# UNITED STATES PATENT AND TRADEMARK OFFICE

APPLICATION NO.	FILING DATE	FIRST NAMED INVENTOR	ATTORNEY DOCKET NO.	CONFIRMATION NO.
10/799,307	03/12/2004	Jae-Hyun Kim	.8054-50 (LW9007US/HJ)	8101

**Office Action Summary**

**DETAILED ACTION**

**FIG. 3B**

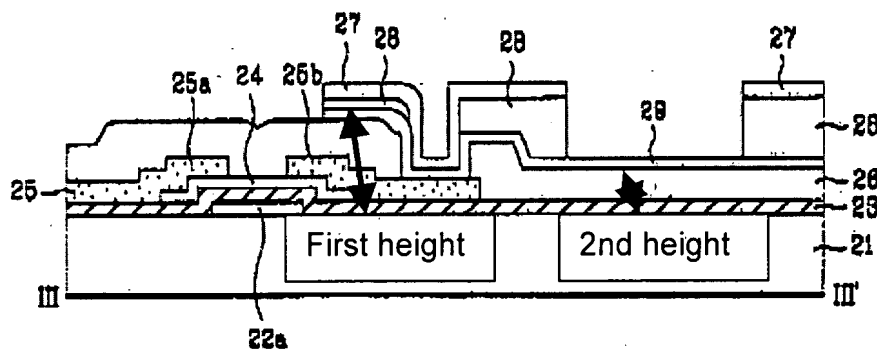
**Claim 17** is rejected under 35 U.S.C. 102(e) as being anticipated by Kim et al (US 6720580).

Kim et al discloses (Fig. 3b) a switching device (22a) formed in a pixel area that is defined by a gate line (22a) and a source line disposed on the first substrate, the gate line extended in a first direction and arranged in a second direction substantially perpendicular to the first direction, the Source line extended in the second direction and arranged in the first direction (shown in Fig. 3a); a pixel electrode (29) connected to a drain electrode (25b) of the switching device; and a reflecting plate (27) disposed on the pixel electrode (29) so as to define a reflecting area from which the natural light is reflected and a transmitting area through which the artificial light is transmitted, wherein the pixel electrode (29) has a first height at the reflecting area (shown below) and a

second height at the transmitting area, wherein the first height is greater than the second height with respect to the first substrate (21), and wherein the reflecting plate (27) has a first edge extended to the transmitting area an insulating layer (26) formed on the switching device and the first substrate with a first contact hole through which the drain electrode (25b) is partially exposed; and an organic insulating layer (28)(Column 6, row 64) formed on the reflecting area with a second contact hole corresponding to the first hole so as to expose the drain electrode (25b).

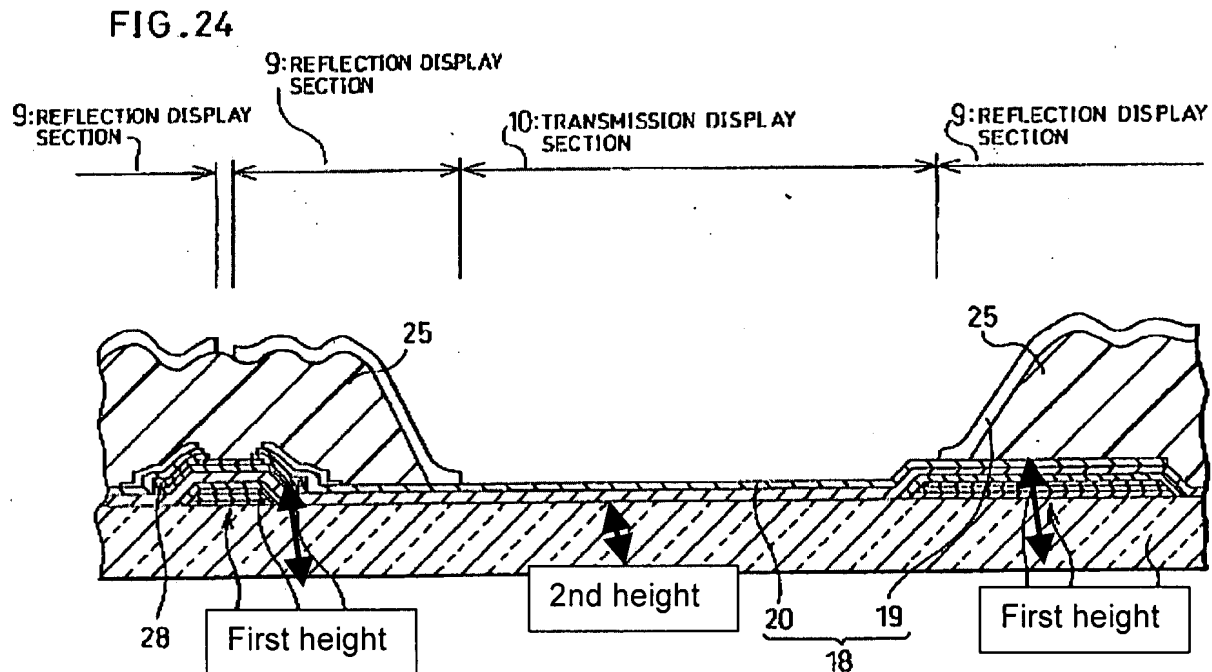
**Claim 19** is rejected under 35 U.S.C. 103(a) as being unpatentable over Kim et al (US 6720580) in view of Baek et al (US 20020036730).

Kim et al does not disclose that the color filters corresponding to the reflecting regions have a larger thickness than the transmissive region color filter and wherein the pixel electrode has a first height at the reflecting area and a second height at the transmitting area wherein the first height is greater than the second height with respect to the substrate

Baek et al discloses (Page 3, [0037]) the color filter layer in the transmitting portion is twice as large as the thickness of the color filter in the reflective portion to improve the color purity of the light passing through the color filter in the transmissive region. (Page 2, [0014], [0015]) therefore the pixel electrode has a first height (d3) at the reflecting area and a second height (d4) at the transmitting area wherein the first height is greater than the second height with respect to the substrate.

It would have been obvious to one of ordinary skill in the art, at the time of the invention to combine the teaching of Kim et al to include Baek et al's color filter thickness to improve the color purity of the light passing through the color filter in the transmissive region. (Baek et al, Page 2, [0014], [0015])
